## Product Change Notification - SYST-04EVDE178

ERRATA - KSZ9477S Silicon Errata & Data Sheet Clarification Errata Document Revision

## KSZ9477S Silicon Errata and Data Sheet Clarification

**FIGURE 1: IEEE DOCUMENT PAGE 6**

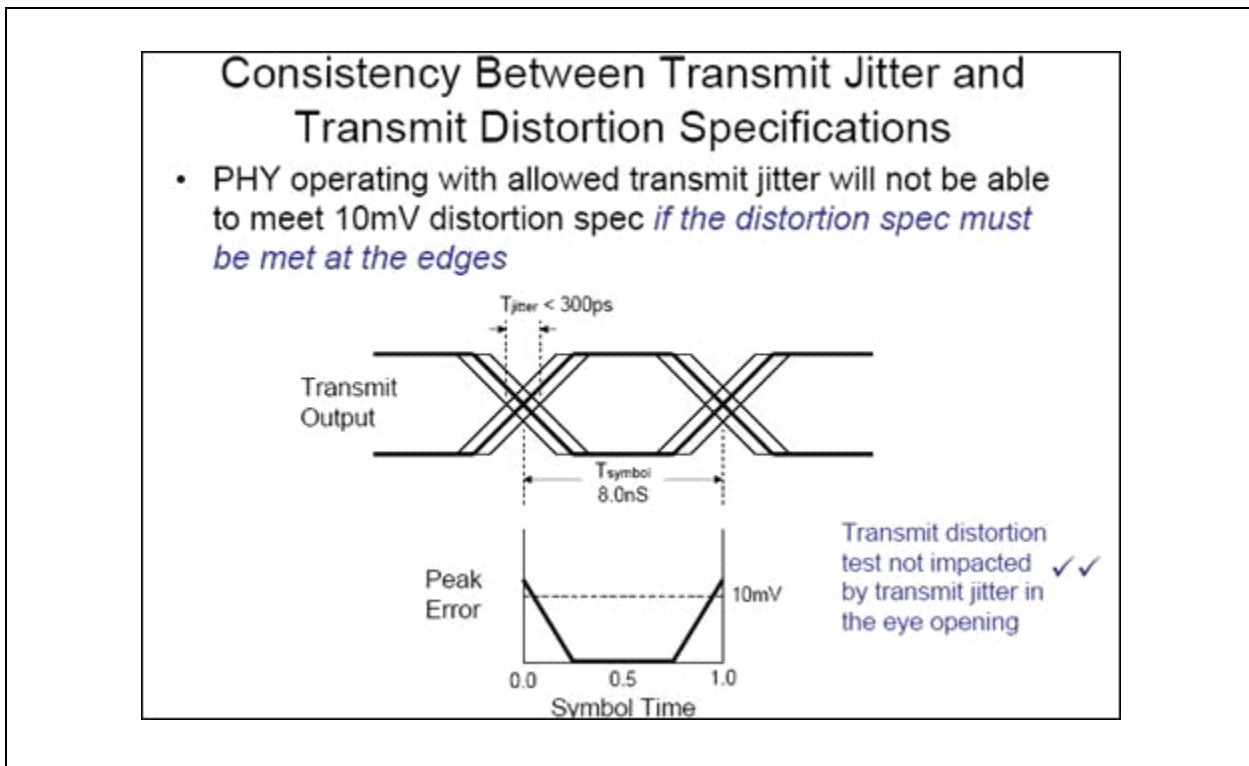
The device's 1000BASE-T Transmitter Distortion is approximately 40mV, versus the <10mV indicated in the IEEE specification.

IEEE testing calls for <10mV peak transmitter distortion for at least 60% of the UI within the eye opening. However, this measurement might not be valid, as the transmit distortion test is sensitive to transmit jitter. Refer to the explanation below, taken from the aforementioned IEEE document.

- On page 6, a contradiction between Transmit Jitter and Transmit Distortion requirements:

Extensive testing has been performed to ensure the device can inter-operate with different Gigabit PHY link partners.

**FIGURE 2: IEEE DOCUMENT PAGE 7**

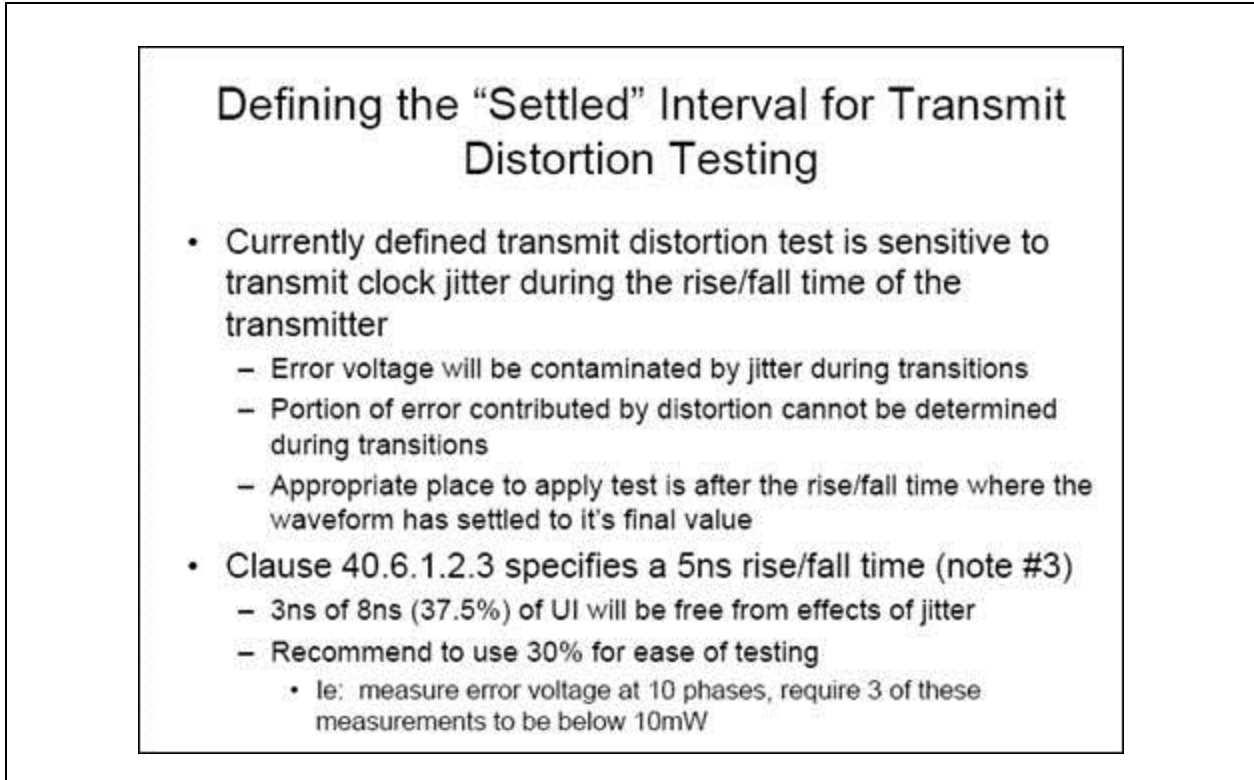
- On page 7:
  - The transmit distortion test is sensitive to transmit clock jitter during the rise/fall time.
  - It is recommended to change the requirement to use at least 30%, instead of at least 60%, of the UI within the eye opening for the <10mV peak transmitter distortion.
